GW-311

Subject: Cotton Draw Compressor Station
Notification of Upcoming Facility Changes
Discharge Permit (GW-311)
Lea County, New Mexico

**ATTACHMENT 1
AMENDED FACILITY PLOT PLAN**

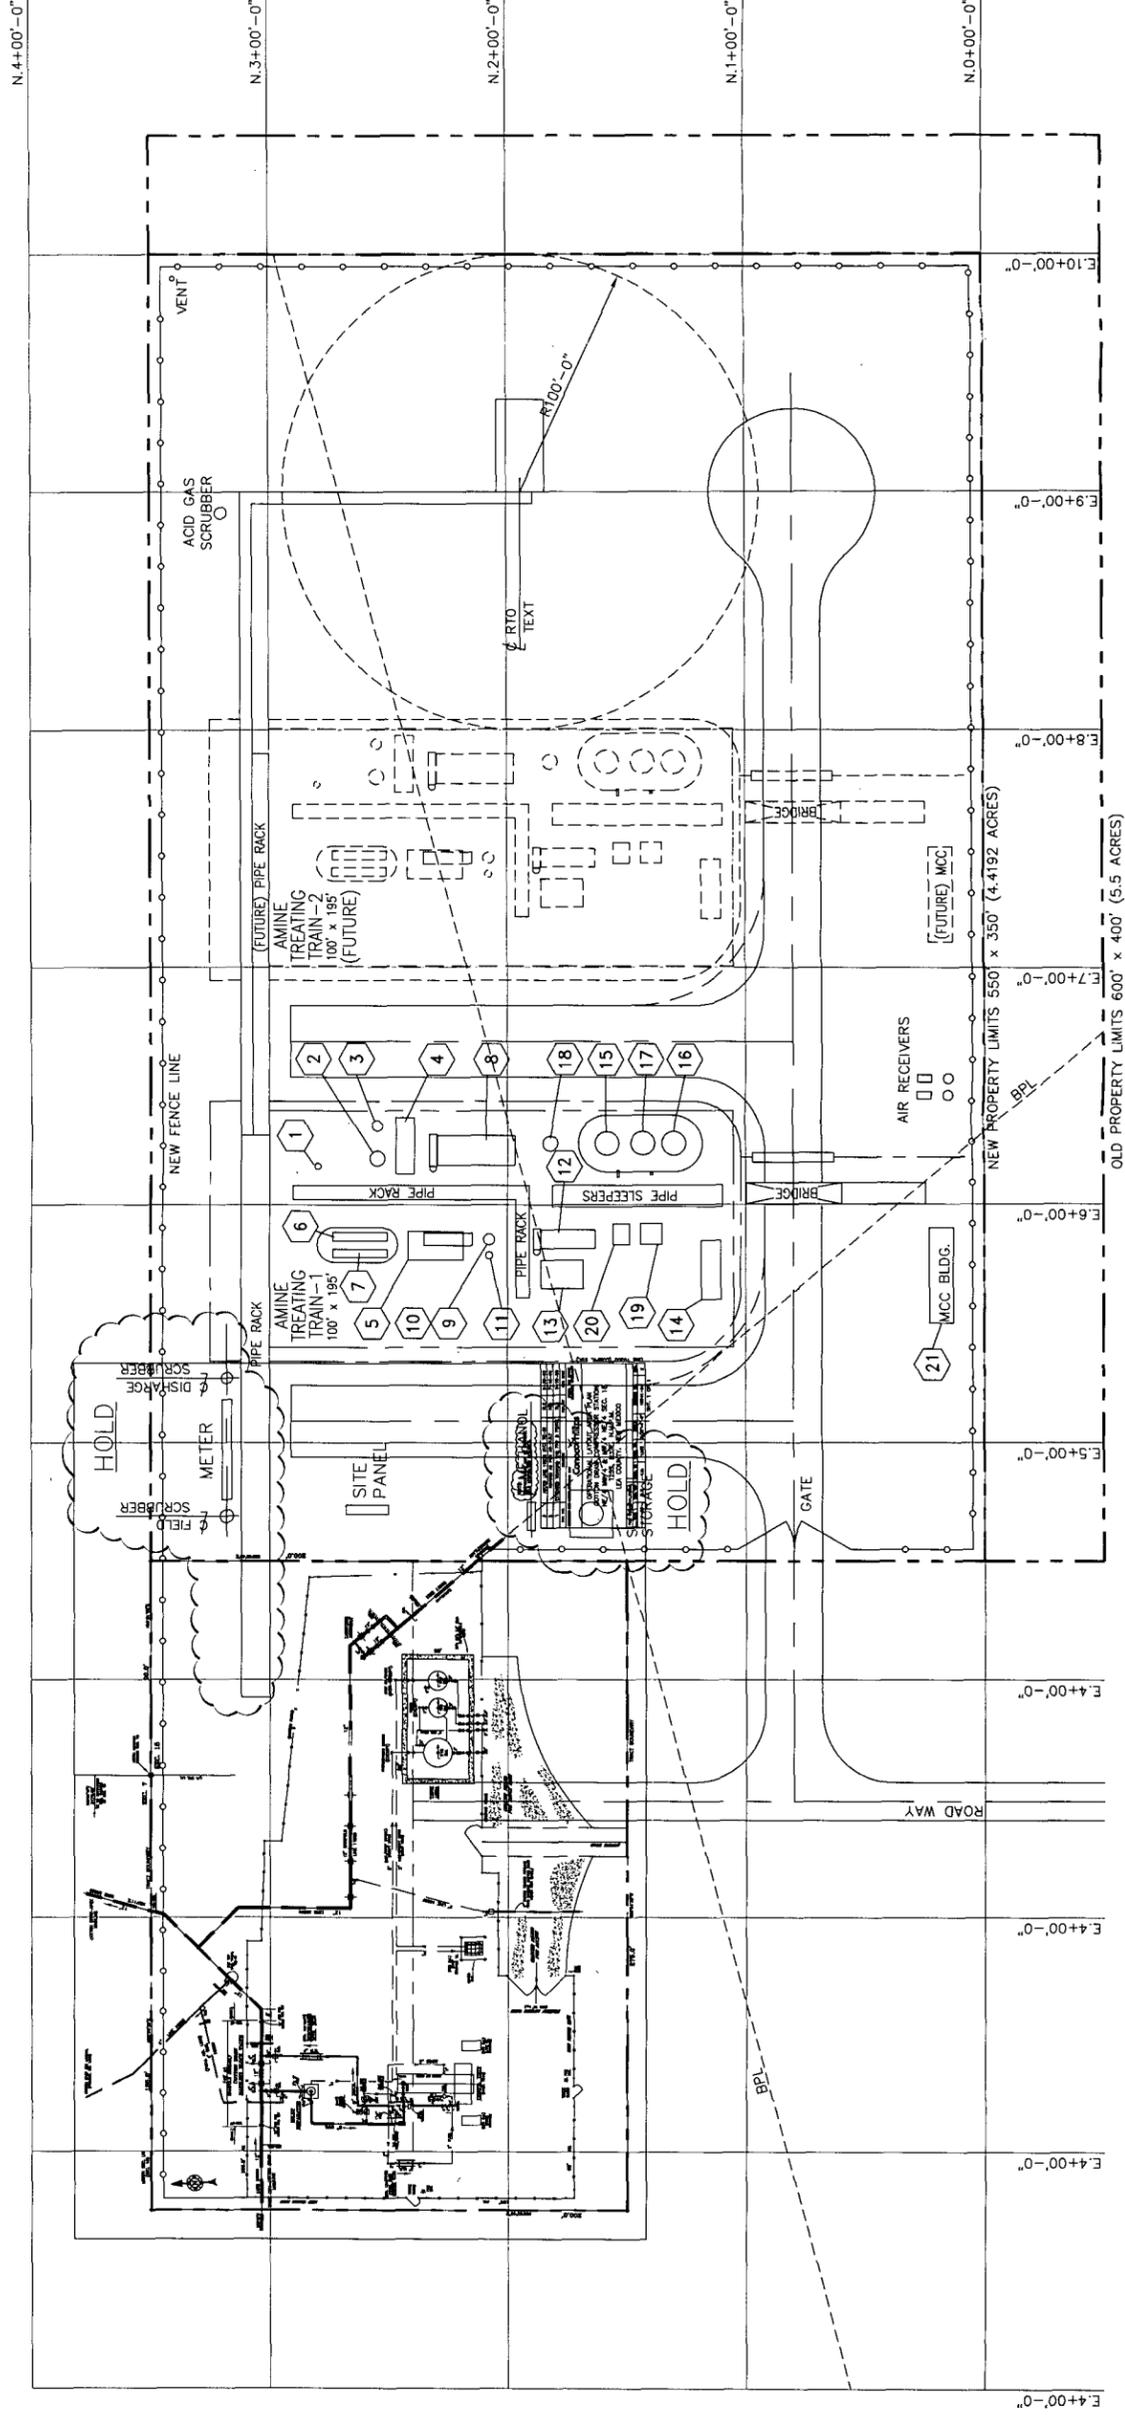
DCP Midstream is planning to add an amine treatment system for the removal of hydrogen sulfide and carbon dioxide to the current facility process. The new treatment equipment (Amine Treating Train -1) will be constructed immediately east of the existing facility equipment. Additionally, a regenerative thermal oxidizer will be installed along the eastern fence line for management/disposal of the recovered hydrogen sulfide and carbon dioxide. An updated facility plot plan showing the relative location of the new equipment, as well as identifying major components of the new treatment system, is provided as Attachment 1. Dashed areas on the facility plot plan show the location of a potential second amine treatment system currently under consideration for future facility expansion work. That additional treatment system is part of a future facility expansion, should conditions warrant, and is not being constructed as part of the current expansion project that is under consideration in this notification.

To support the operation of this new system, a new 210-barrel Amine Storage Tank and two 210-barrel Demineralized Water Tanks will be utilized. These new aboveground storage tanks will be placed inside a new impermeable secondary containment berm sized to hold at least 133% of

ATTACHMENT 3
470-GALLON BELOW-GRADE TANK DETAIL

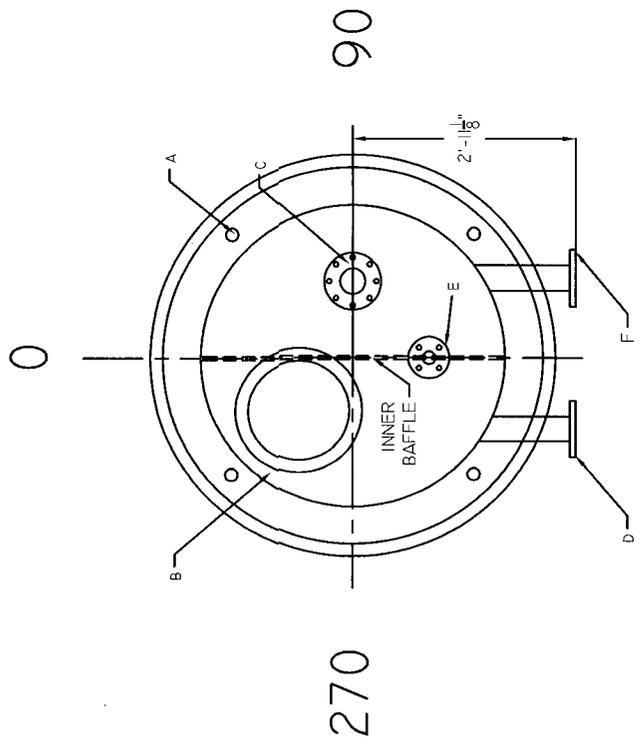
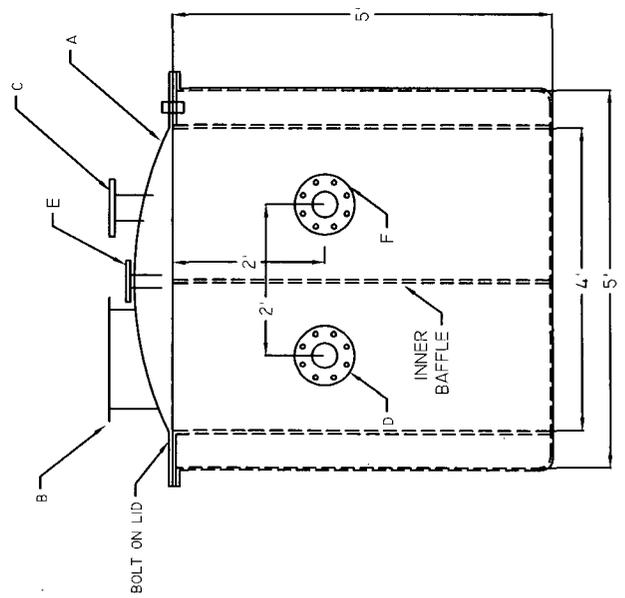
Much of the treatment system equipment will be placed atop concrete foundations equipped with environmental drains. The concrete foundations will prevent incidental leaks of oil, amine, and other system fluids from making contact with the ground surface in the immediate vicinity of the equipment. Fluids captured by the foundation drain system will gravity flow to a new 470-gallon Open Drain Sump (which meets the NMOCD definition of a below-grade tank) before being transferred to the facility Produced Water Tank via the Oily Water Tank for future off site disposal. This system is included to prevent stormwater that may come into contact with de minimis amounts of oil, amine, and other equipment fluids from discharging from the facility via sheet flow stormwater runoff. The below-grade tank will be constructed of fiberglass with a vinyl ester corrosion barrier, and will be double-walled (tank-in-a-tank design) to provide appropriate secondary containment to minimize the potential for an inadvertent release of oil or other fluids to the surrounding environment. Four view ports will be provided on the top of the tank to provide leak detection capability and allow for visual inspection of the interstitial space and primary tank walls. Level controls will be incorporated into the tank design to provide timely, automatic emptying of the tank via an air driven diaphragm pump to prevent accidental overfilling of the tank. The pump will be activated once the level in the primary tank reaches 50% of the primary tank's volume. A drawing showing the details of the below-grade tank is included as Attachment 3.

In addition to the Open Drain Sump, a 470-gallon Amine Sump (which also meets the NMOCD definition of a below-grade tank) will also be installed. This below-grade tank will be identical in construction and operation to the Open Drain Sump described above.
